# Technical Service Bulletin

<b>Subject:</b>  CREAKING NOISE FROM STEERING COLUMN	<b>Bulletin No.:</b> 06-004/23
	<b>Last Issued :</b> 09/07/2023

2016-2023 CX-9 vehicles with VINs lower than JM3 TC\*\*\*\* \*\* 657869 (Produced before Mar. 13, 2023)

## Lot number verification:

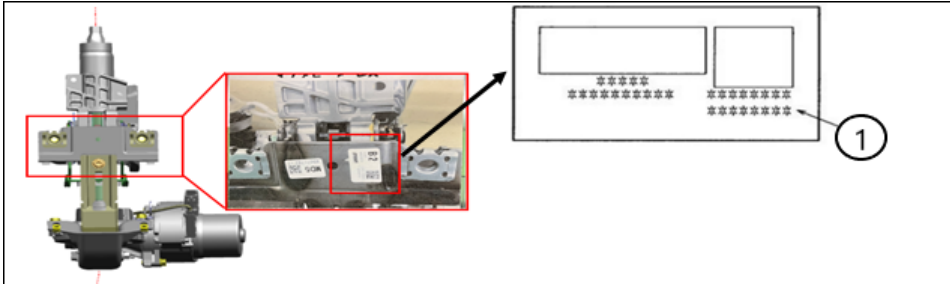
Verify the lot number printed on the sticker (1).

The first digit indicates the year of the production date, the second is the month, the third and the fourth are the day.

**NOTE:** From January to September, the months are represented with their correspondent number (from 1 to 9). The remaining months are represented by a letter (October=X, November=Y, December=Z).
